**CYNGOR SIR  
YNYS MÔN  
ISLE OF ANGLESEY  
COUNTY COUNCIL**

**EXTRAORDINARY  
MEETING OF THE  
ISLE OF ANGLESEY  
COUNTY COUNCIL**

**THURSDAY, 24 JANUARY 2013**

**3     ON-SHORE WIND ENERGY SUPPLEMENTARY PLANNING GUIDANCE  
(Pages 1 - 244)**

#### 5.12 Wind Power Potential on Ynys Môn – Strategic Assessment

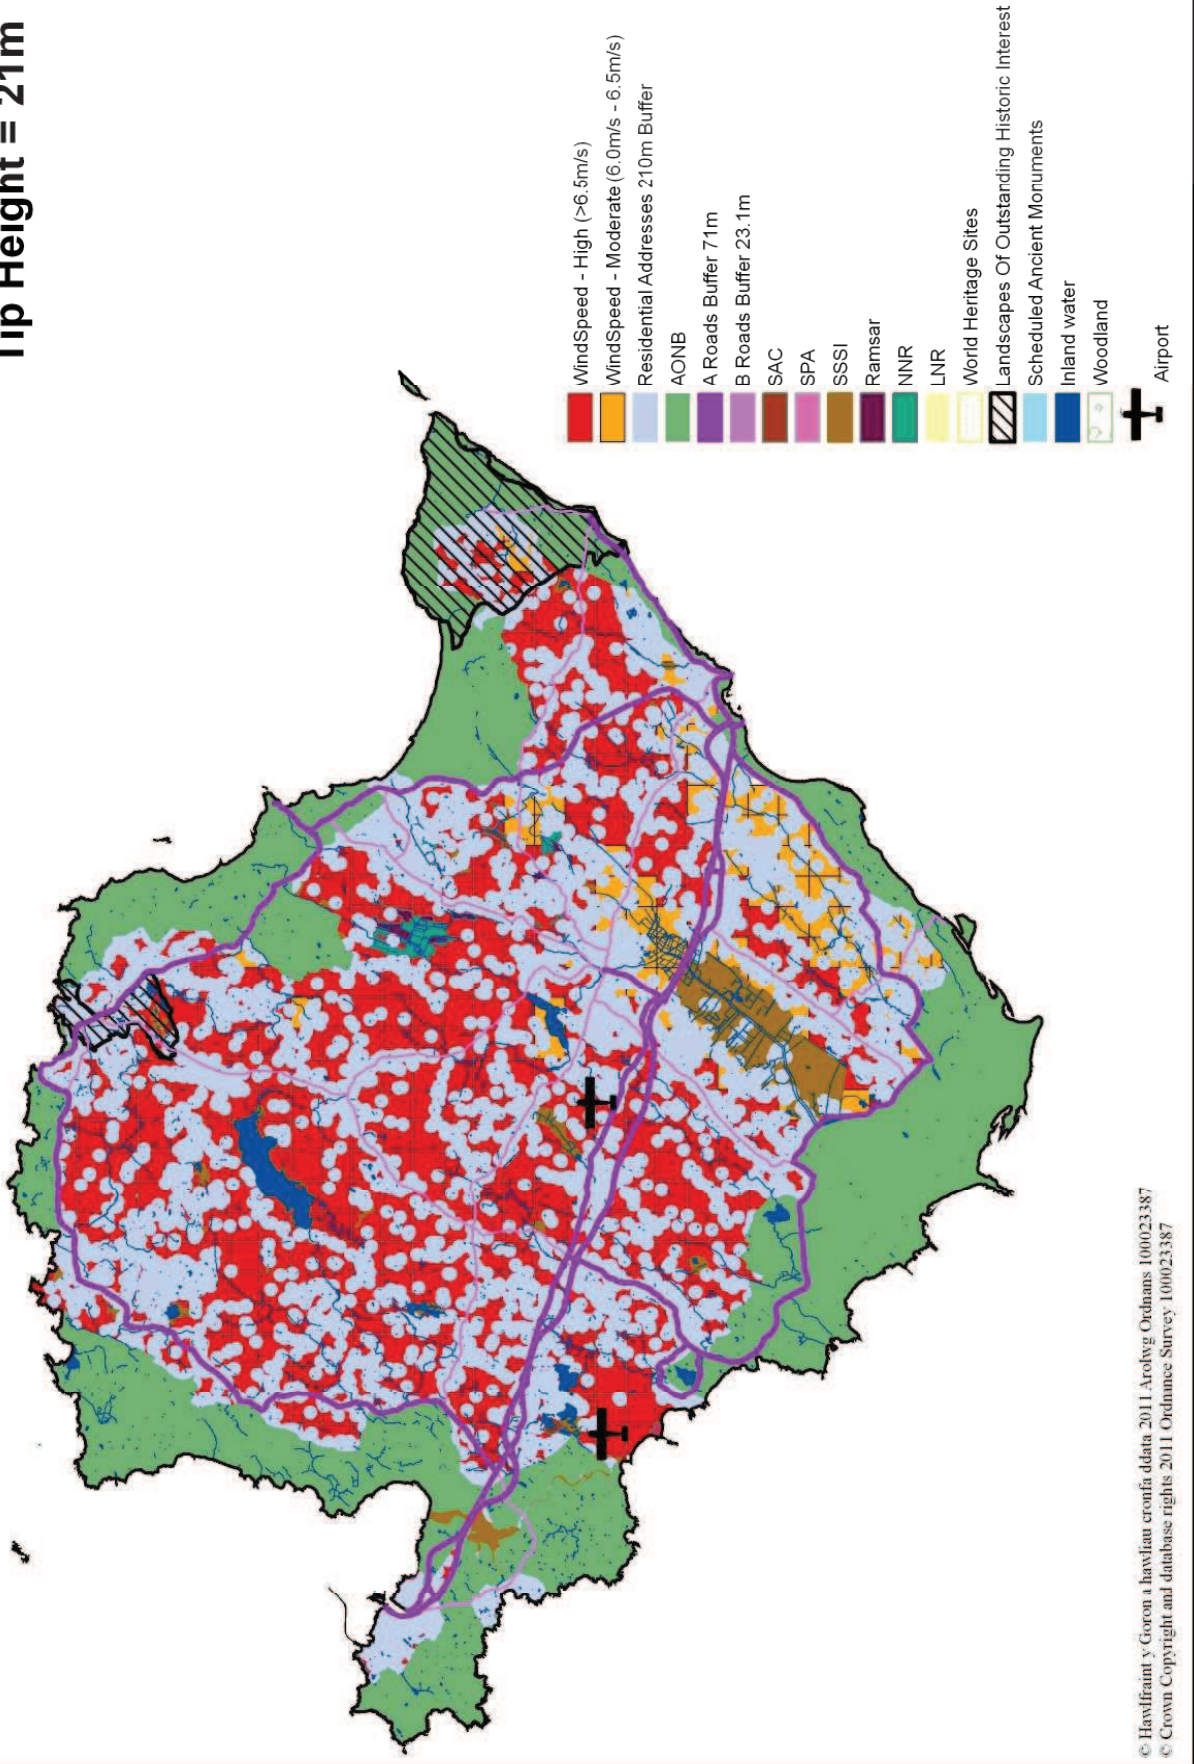
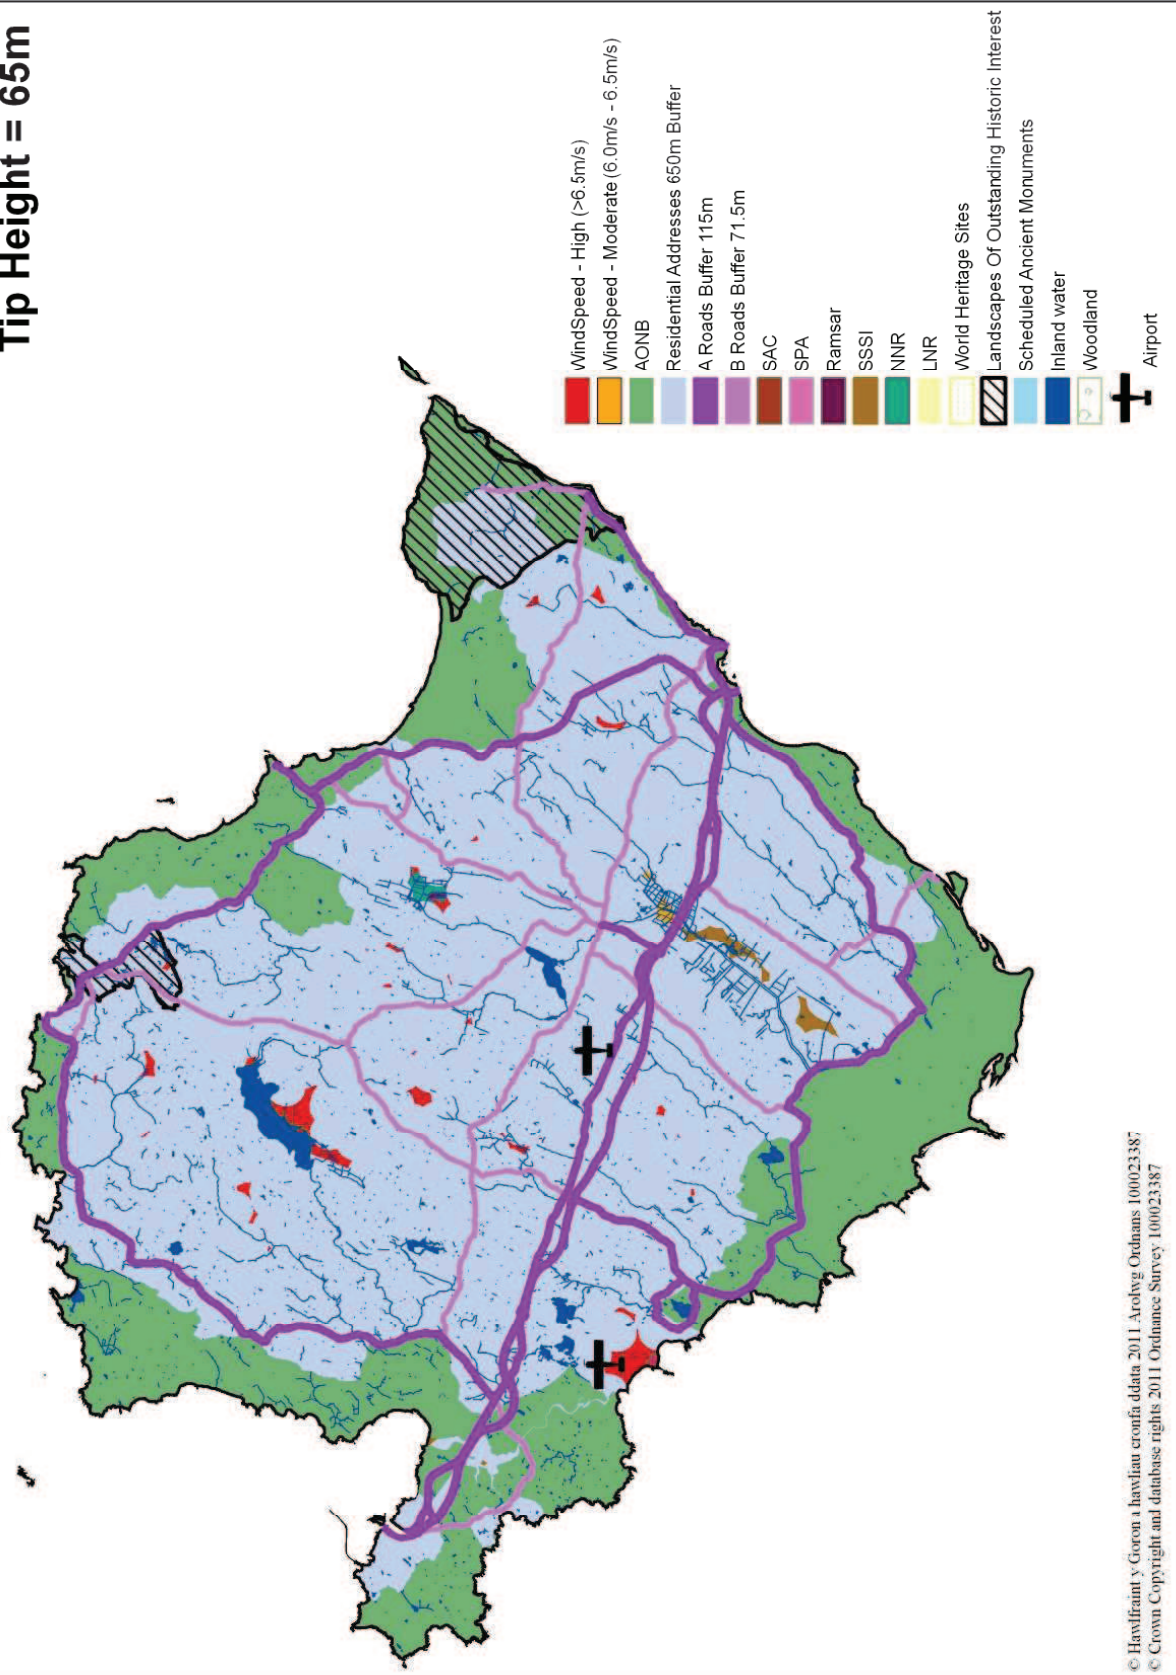
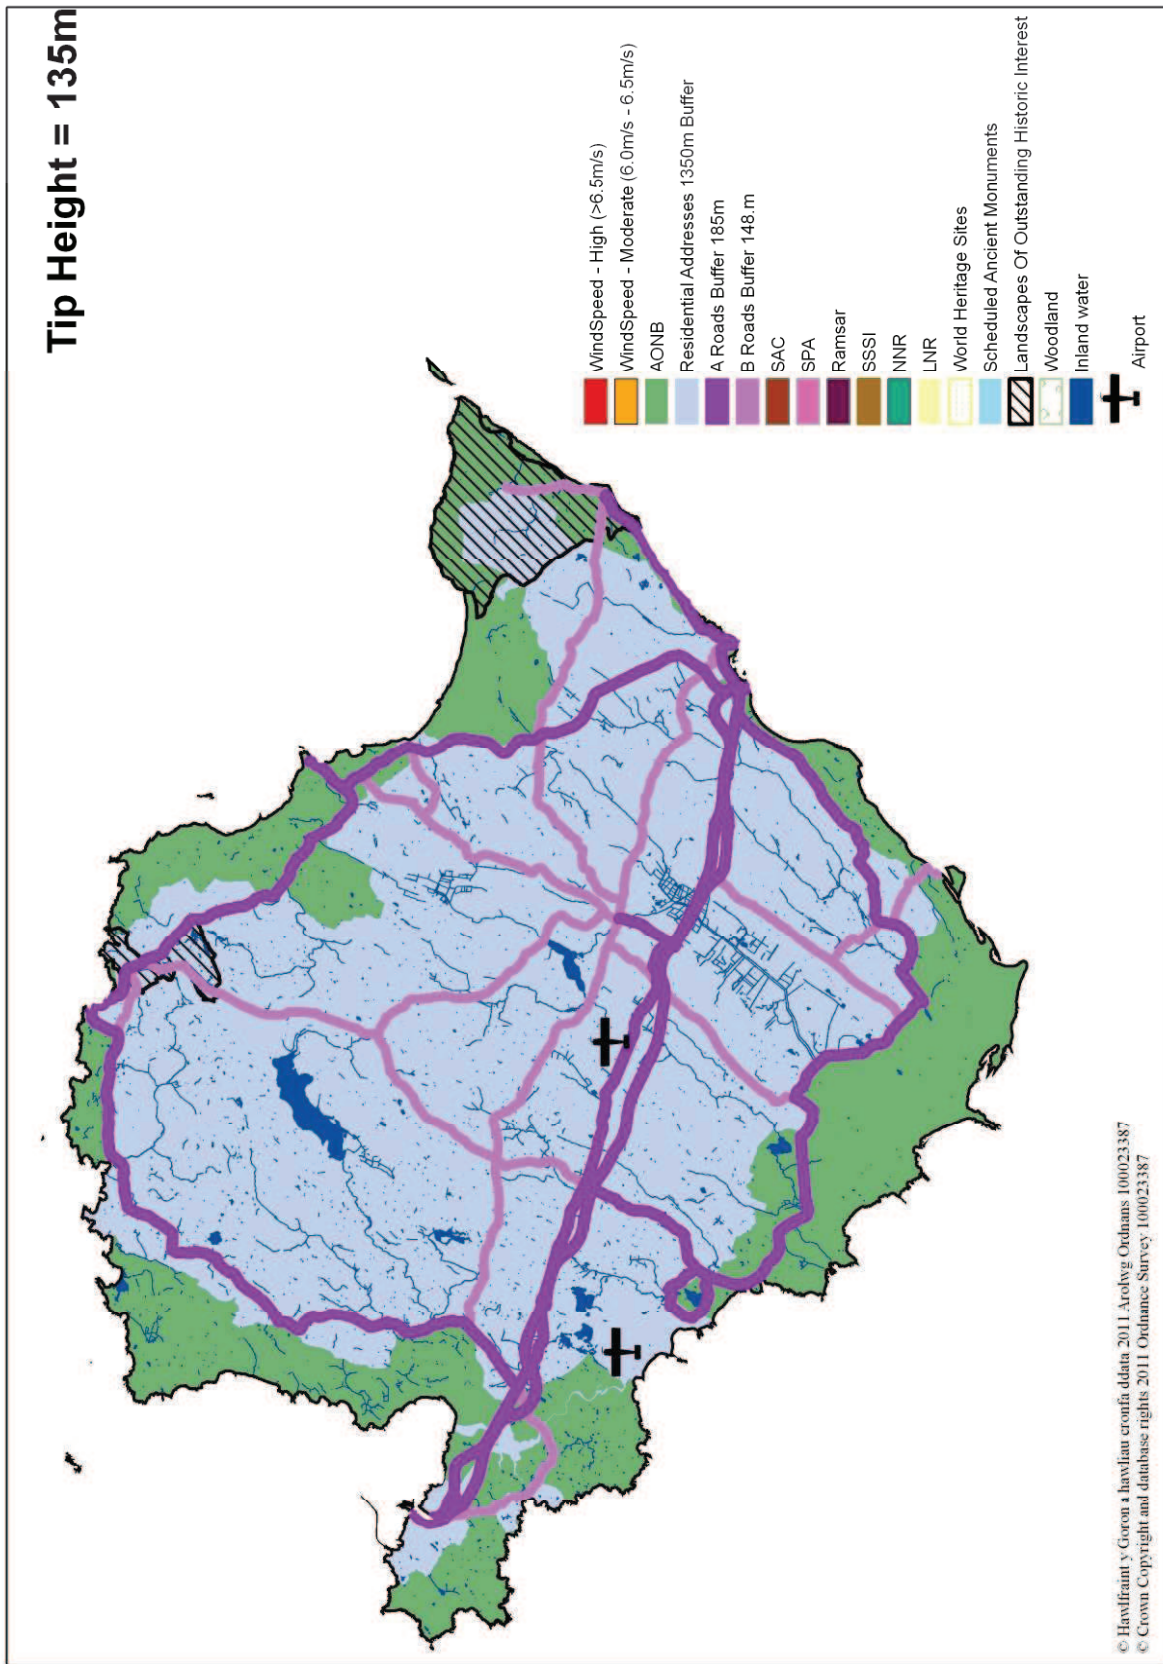
AY108	5	5.12 and Maps 1 - 3	Maps to include a buffer zone around the AONB and all SACs/SPAs/SSSI.	to address the requirements of Regulation 39 of the Conservation Regulations 2010	Regulation 39 of The Conservation of Habitats and Species Regulations 2010 refers to nature conservation in planning contexts and requires land use policies on development and use of land and conservation to take into consideration the need to encourage the management of landscape features which are of importance to wild fauna and flora. Will apply to new LDP not existing policy framework. Does not include reference to buffer zones	No change
AY116	5	5.2	There should be a buffer zone around AONB in which no turbines greater than 20 metre high are allowed. This buffer zone should be 2km wide or greater.	No evidence to support comment submitted	No specific evidence submitted in support of the comment made	No change
AY118		5.2.3 7.9	Call for no commercial wind turbines in any	No evidence to support comment submitted	No specific evidence submitted in support of the comment made	No change

**Table 4**

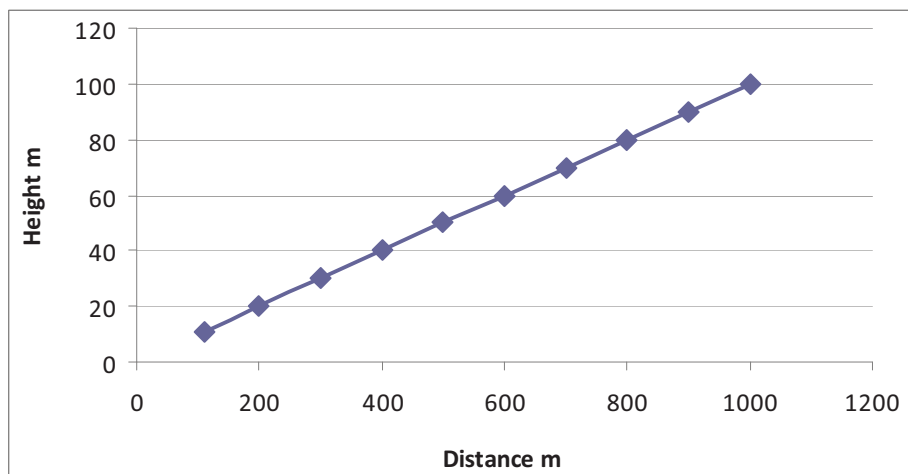
AY045		5.2.3 7.9				
AY046		7.9.8	At the very least, the 500 meter separation should be adhered to, with table 4 imposed on top, i.e. small turbine 11.1m — 20m tip separation distance should be 611 meters — 700 meters.	No evidence offered in support of statement	No specific evidence submitted in support of the comment made	No Change
AY049		7.9.8				
AY050		7.9.8				
AY051		7.9.8				
AY052		7.9.8/7.9.9	Paras 7.9.8 – 7.9.9 are misleading and it is suggested that they should either be deleted or at the very least re-worded. Use of the term "minimum separation distances" in these paragraphs is very misleading and will lead to confusion	Whilst WCE have no objection to the inclusion of some sort of trigger mechanism for providing a RAA, it should clearly be termed as such and not referred to as a "minimum separation distance". This is misleading to any reader of the guidance – including developers, Councillors, and members of the public.	Agree that this could be misleading.	Amend to exclude reference to minimum distances

AY079		7.9.8	At the very least, the 500 meter separation should be adhered to, with table 4 imposed on top, i.e. small turbine 11.1m — 20m tip separation distance should be 611 meters — 700 meters.	No evidence offered in support of statement	No specific evidence submitted in support of the comment made	No Change
AY080	7	7.9	In response to the consultation we the undersigned call for a 1.5km separation distance between any commercial wind turbine development and residential properties.	No evidence offered in support of statement	No specific evidence submitted in support of the comment made	No Change
AY081		5.2.3 7.9	We support the AAWT petition calling for no commercial wind turbines in the AONB and a minimum of 1.5 KM separation distance between any commercial wind turbine development and residential properties.	No evidence offered in support of statement	No specific evidence submitted in support of the comment made	No Change
